# Instruction for hydraulic filter

BM-795120

ANV152

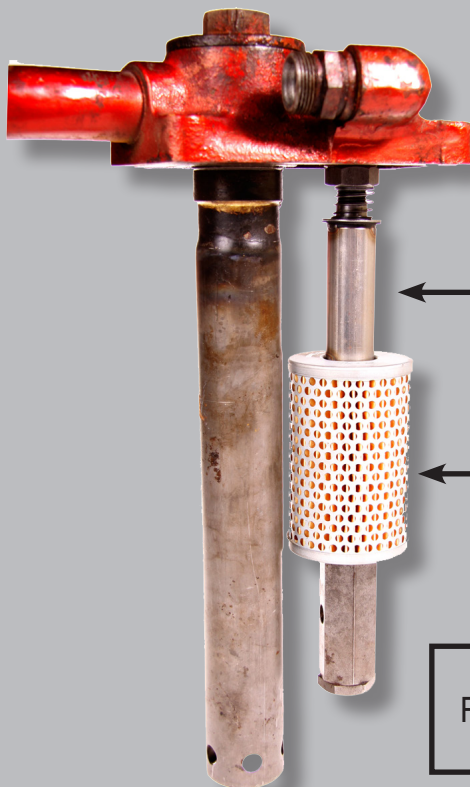
Original design

Replacement design

Fit the new hydraulic filter part no. BM-795120 in the following order:

The spacer sleeve is positioned on top.

The filter is positioned under the spacer sleeve.

Recommended change interval: 500 hours
